From: Schlichtemeier, Chad
Sent: Monday, November 11, 2024 2:47 PM
To: Friedman, Rachel
Cc: Schlichtemeier, Chad
Subject: FW: [EXTERNAL] Re: Wildlife Protection Plan and Wetland Delineation Memo - Parsnip Fed Pad

Rule 1202.a.(3) (creeks/wetlands) Waiver Assessment

1202a(3) EXHIBIT
PARSNIP FED HZ

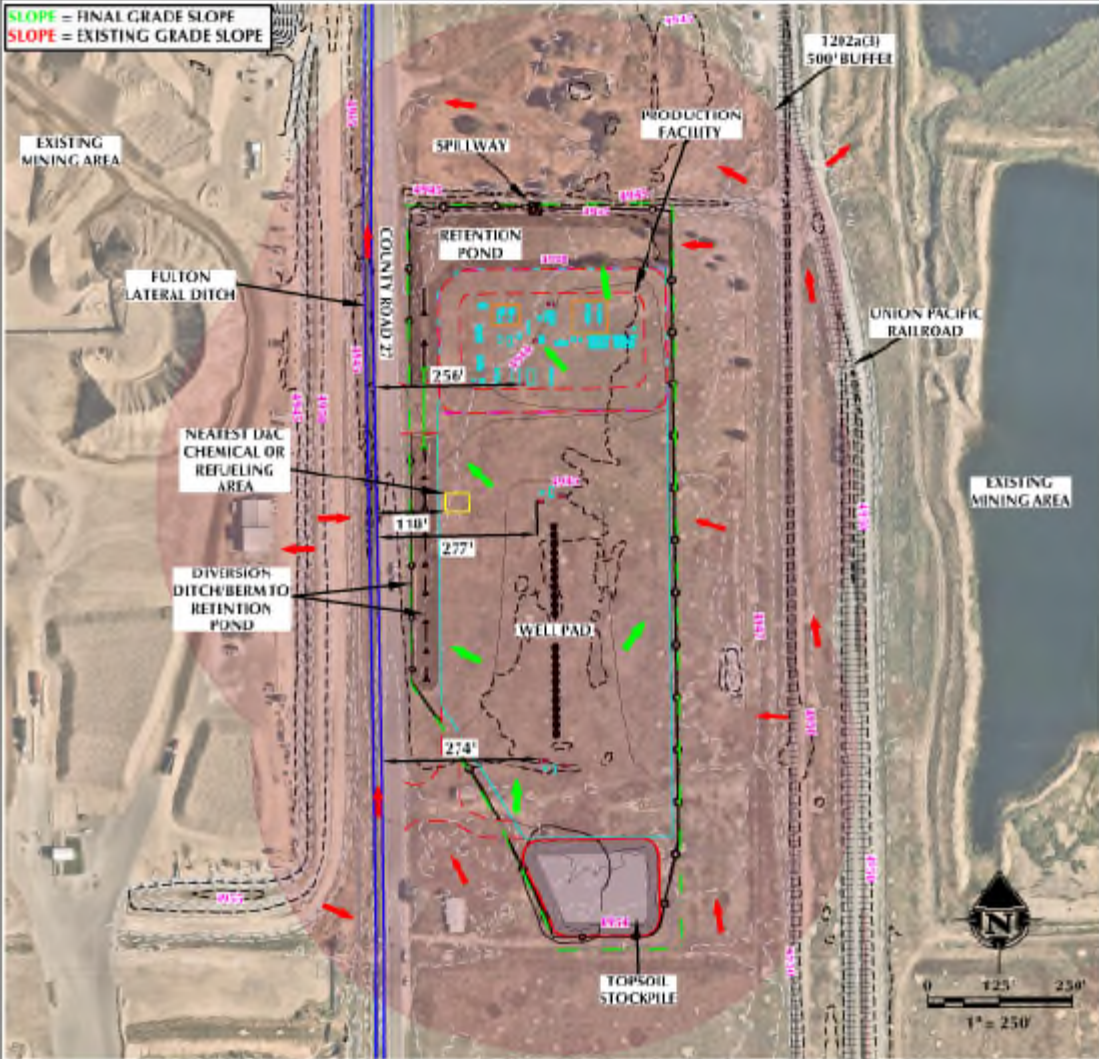
- During the October 2024 delineation, Fulton Ditch, was identified which had an Ordinary High-Water Mark(OHWM) ± 118 feet southwest of the proposed produced water tanks, maintenance tanks, and water vault.

- The closest edge of the irrigation ditch is located ± 60 feet downgradient of the chemical storage totes, but the pad itself is downgradient of CR 27 which is raised preventing flow from the pad to the ditch (creating a barrier).

- This location does not occur within Aquatic High Priority Habitat.
- The pad will be graded so that all stormwater flows to the retention pond on the north side of the pad with no discharge during normal operation. Water will be dissipated from the pad via Infiltration. The Working Pad Surface will have an approximately 3-foot stormwater detention berm around it.

- KMOG stated that *"the chemical totes that are used on KMOG locations in the DJ contain built in secondary containment and are made of steel. All other tanks on location will be within steel bermed secondary containment compliant with EPA rule 40CFR 112 Subpart A, B, C.."*

- Therefore, because of the above discussion, and because the Fulton ditch within 500 feet of the WPS is not mapped as an Aquatic Native Species Conservation Water, CPW grants KMOG this signed waiver (per the requirement discussed in ECMC Rule 1202.a.(3)) requiring chemicals and new sites to be located more than 500 ft away from the wetlands and ditches.
